Peirce Island Wastewater Treatment Facility Upgrade
Value Engineering Study Report

August 2014

Subject:
Peirce Island Wastewater Treatment Facility Upgrade
Value Engineering Study Report

PROJECT: **PEIRCE ISLAND WASTEWATER TREATMENT FACILITY UPGRADE** *City of Portsmouth, New Hampshire*		ALTERNATIVE NO.: **H-7**
ORIGINAL DESIGN ☐	ALTERNATIVE DESIGN ☒ BOTH ☐	SHEET NO.: **2 of 3**

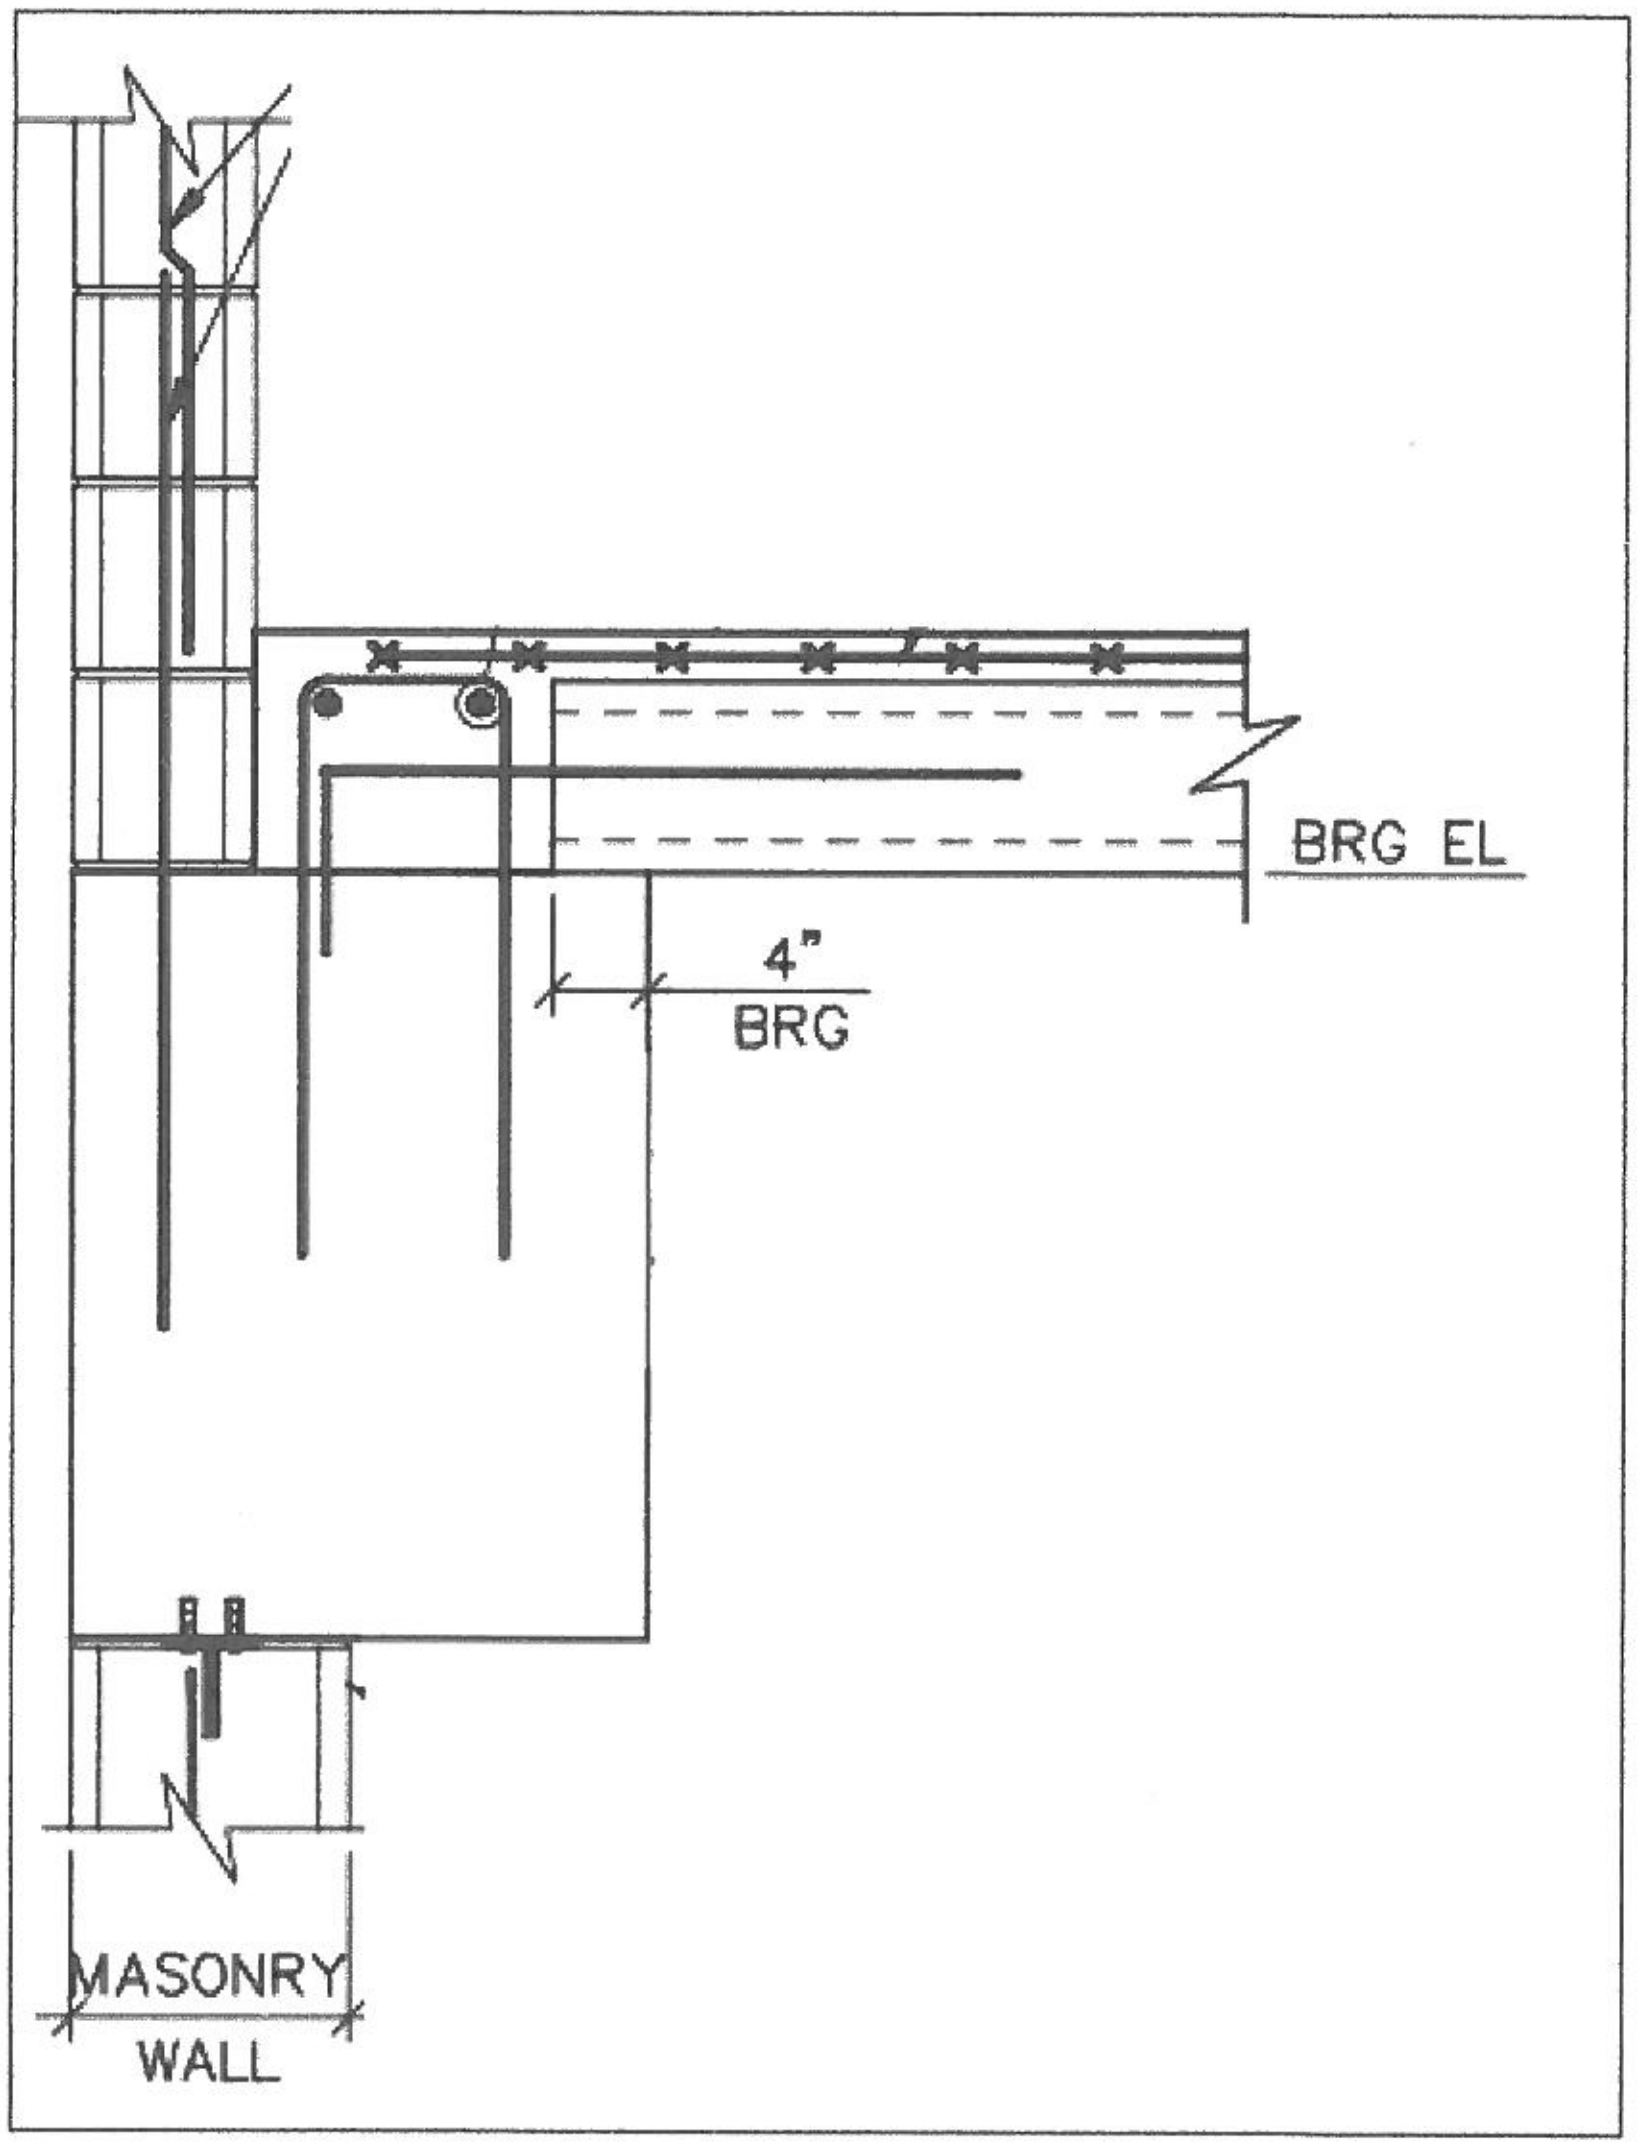
Use precast concrete roof planks with a cast-in-place (CIP) concrete topping.

The VE team feels that precast roof plank would be a valid option for this project. Precast roof plank can provide equivalent strength and durability properties to CIP concrete. Using precast plank would reduce the construction duration and reduce the amount of construction traffic to and from the project site. The precast plank could be used in conjunction with the concrete moment frame and provide diaphragm action support.

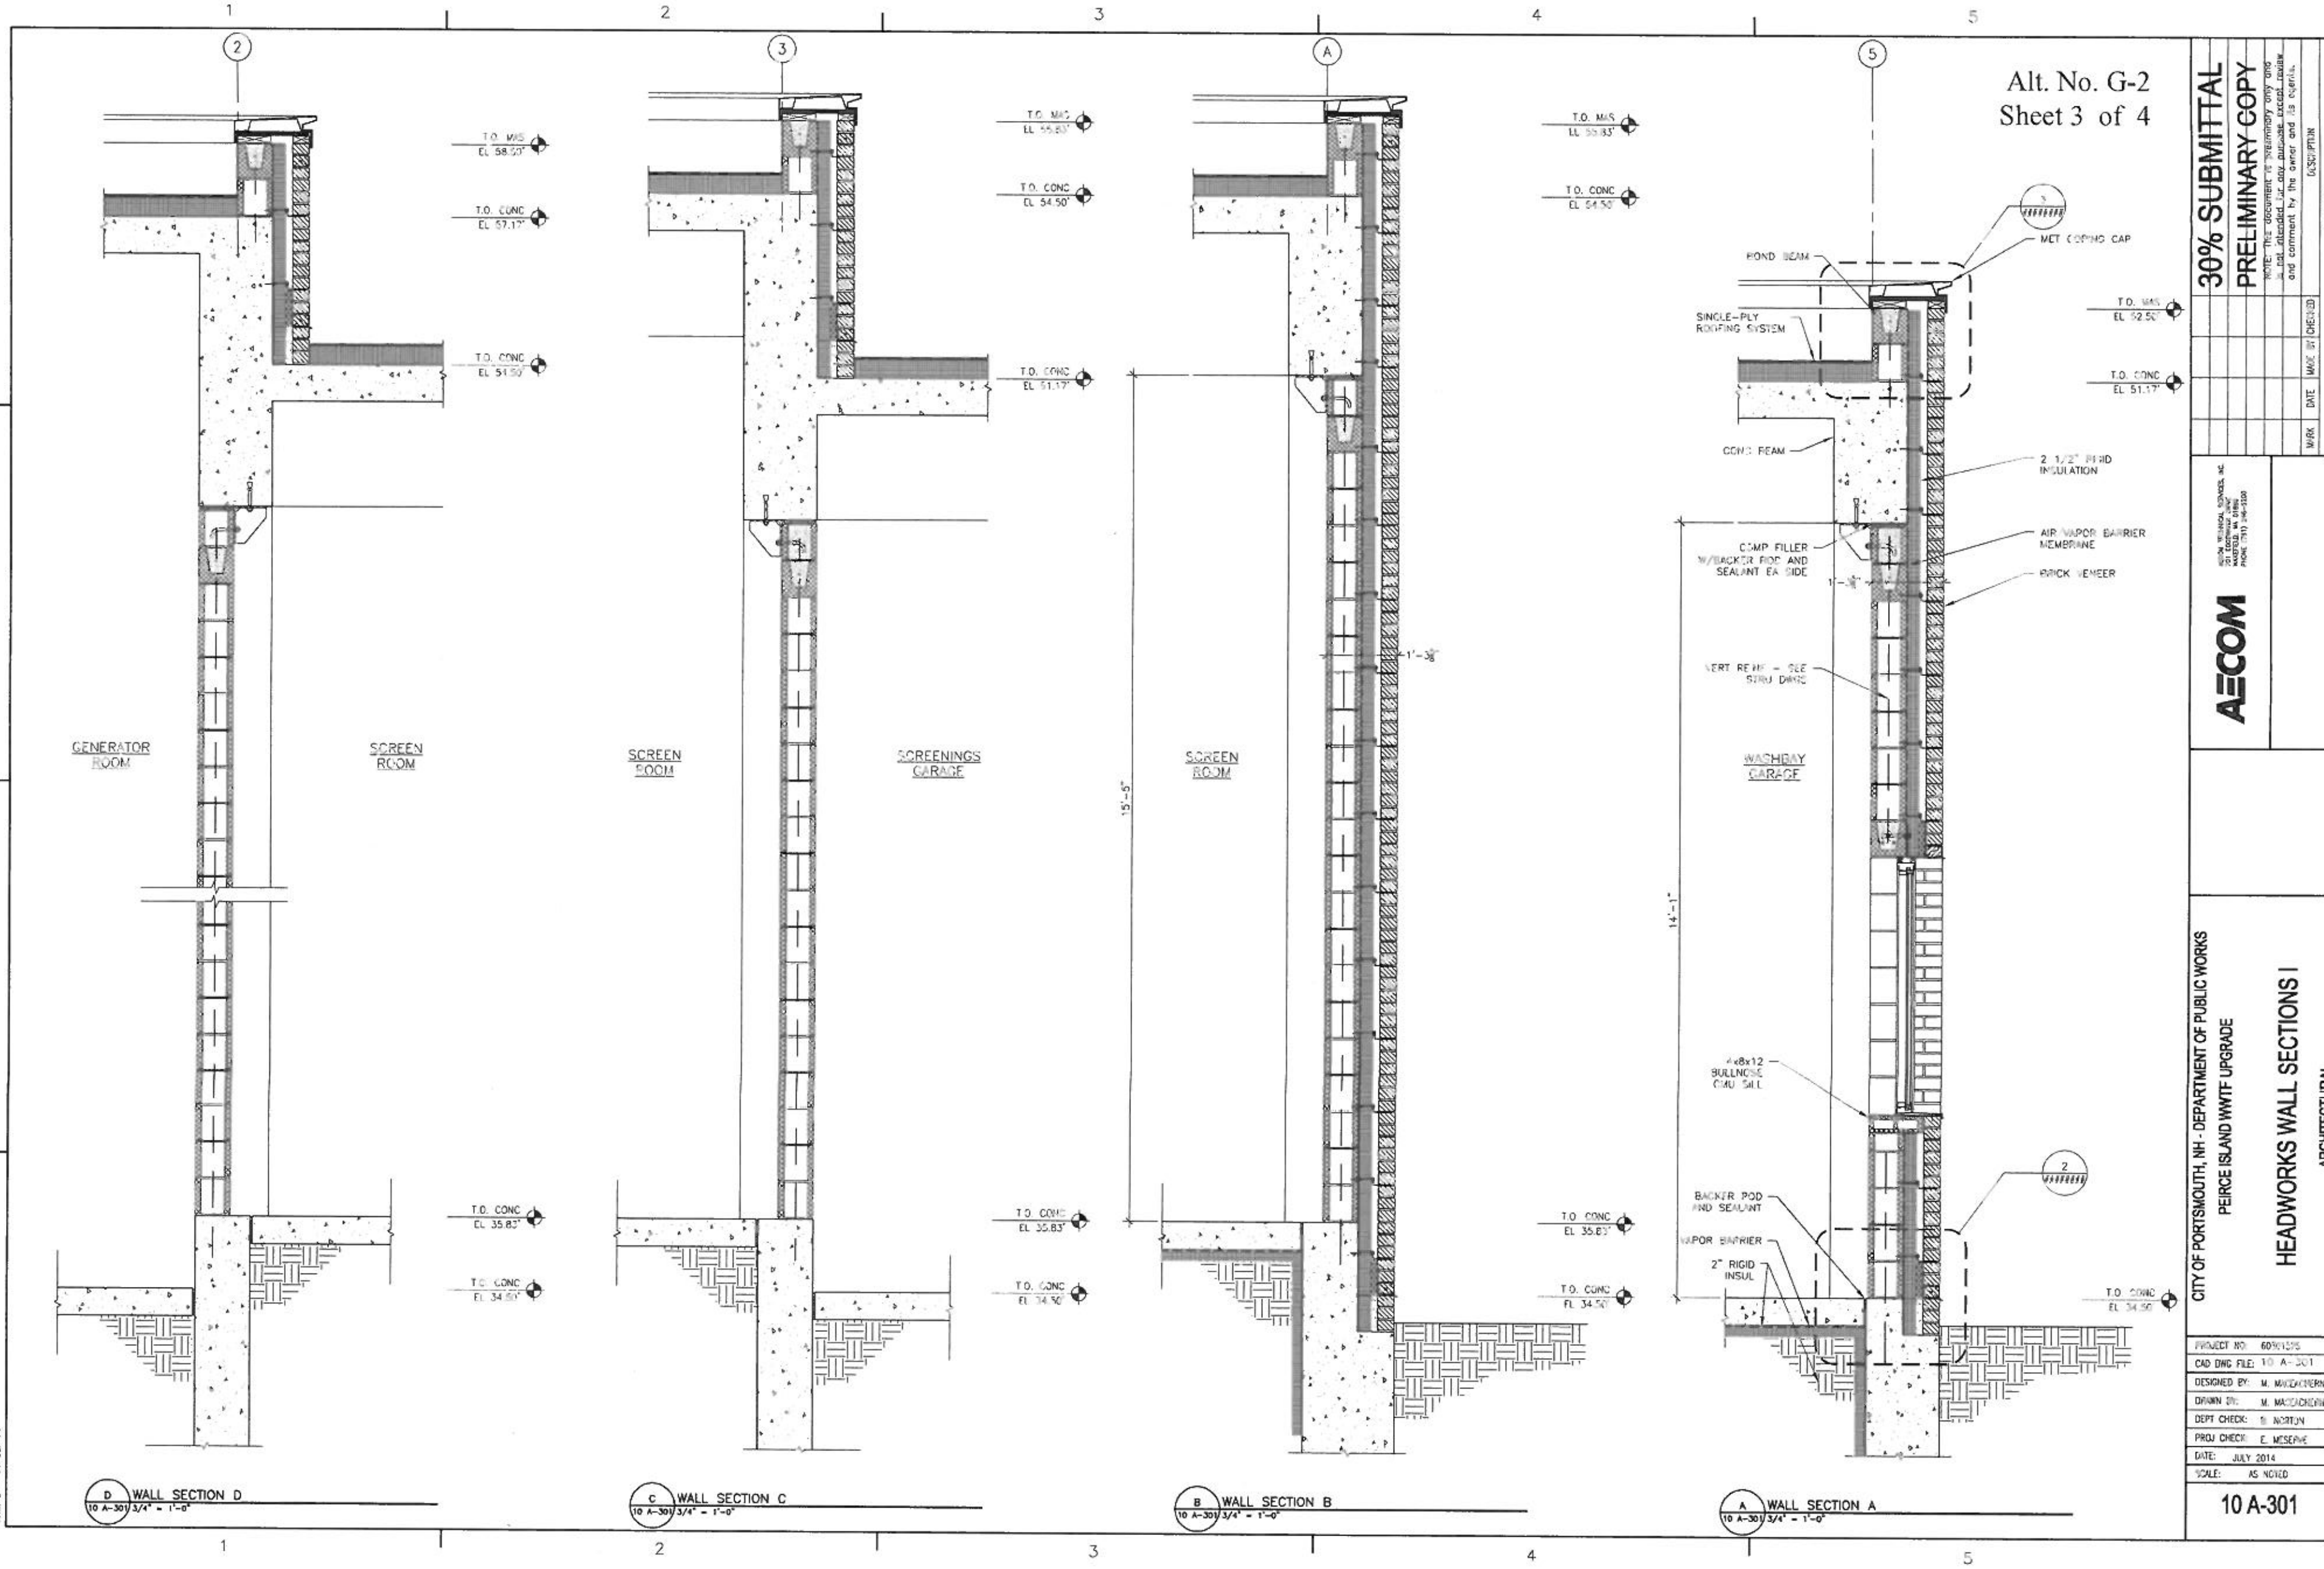
Operations and Laboratory Building – Replace the proposed lower level concrete block / brick cavity wall construction and upper level metal studs with a brick veneer with an insulated architectural precast wall panel with a brick veneer to match existing.
